Dose Requirement for the LENA Instrument on IMAGE

Prepared by Janet Barth
Radiation Physics Office
Code 900, Earth Sciences Directorate
(301) 286-8046

Dose-Depth Curves, 2-Year Mission Duration
 IMAG E: ±90 deg, H=1000/4000 km, Solar Maximum

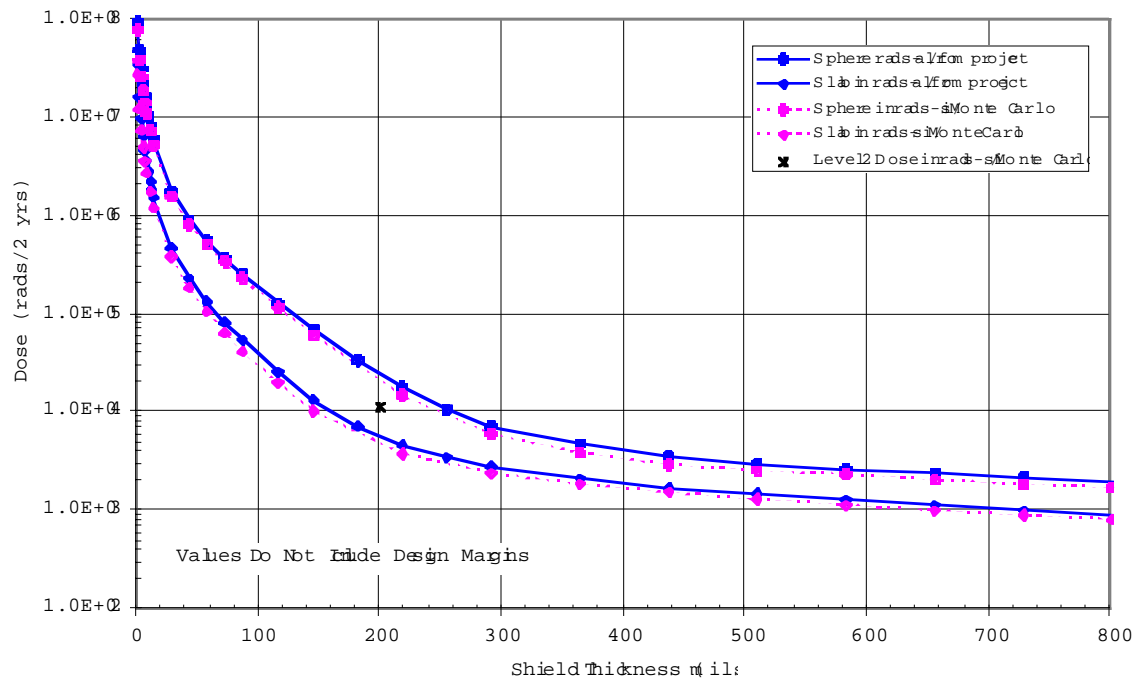
The table shows that, even when increasing the number of solar proton events to 3, the more realistic model predicts only 11.37 krads_{si} for the 2-year mission. When this total dose prediction is entered on the figure below at 200 mils of shielding, it can be seen that the Level 2 prediction falls between the 2 x slab and solid sphere predictions as expected.
